Record of Briefing

Sydney Western City Planning Panel

PPSSWC-372 – Fairfield – DA 294.1/2023 – 17 Lupin Avenue, Fairfield East

Demolition of existing structures, tree removal and construction of a residential flat building containing thirty-nine (39) affordable housing dwellings over basement car parking containing 40 parking spaces and associated landscaping in accordance with State Environmental Planning Policy (Housing) 2021.

Figure 3F.3 New development adjacent to existing buildings should provide adequate separation distances to the boundary in accordance with the design criteria

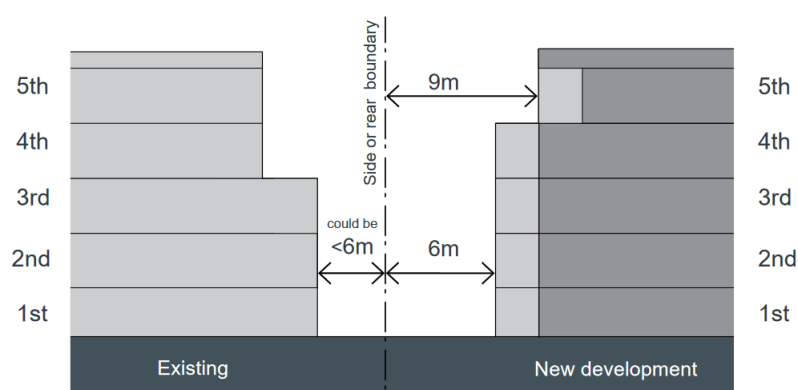
The appropriate application of cl 7.4.3 of the DCP to regulate setbacks from streets was also discussed. Under that clause the 6m front setback area of a Residential Flat Building development to a frontage is not to be used for any purpose other than landscaping. Development is permitted to within 3 metres of any secondary street frontage for no more than 25% of the secondary street frontage only.

Those details can be compared to the guidance in the ADG:

Council has suggested that one way to ameliorate the non-compliances with the encouraged setbacks and associated privacy issues would be to relocate the basement driveway under the building to open up the adjacent setback for landscaping and tree planting.

The Applicant indicated that it was willing to consider that change, and the Panel encouraged discussions to that end.
